# Mask Set Errata for Mask 3L47P

This mask set errata applies to the mask 3L47P for these products:

- MC68HC908AP64
- MC68HC908AP32
- MC68HC908AP16
- MC68HC908AP8

Figure 1. Typical ADC Error Count

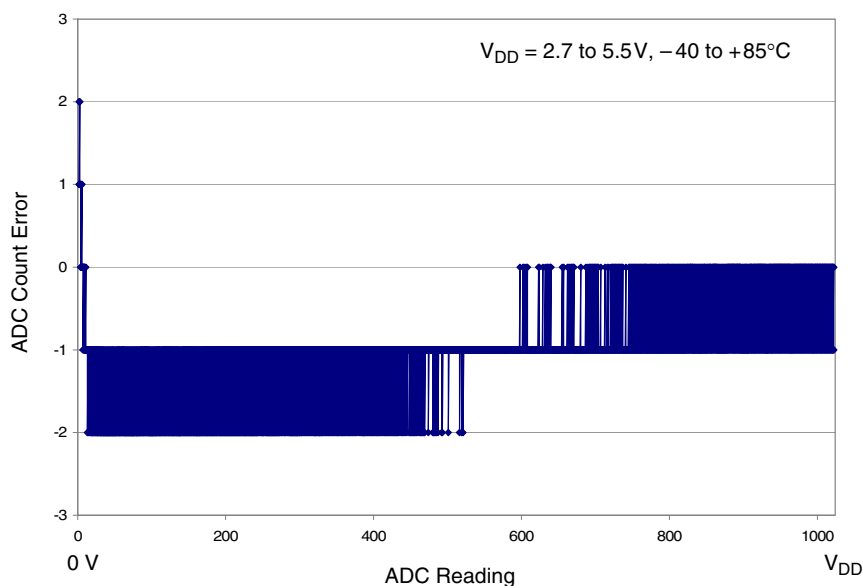
The 10-bit ADC conversion result for 0V input (zero input reading) is \$000, \$001, \$002, or \$003; not the specified \$00 or \$01. With inputs of 5mV and above, the ADC is within the specified accuracy of  $\pm 1.5$  LSB (see [Figure 1](#)).
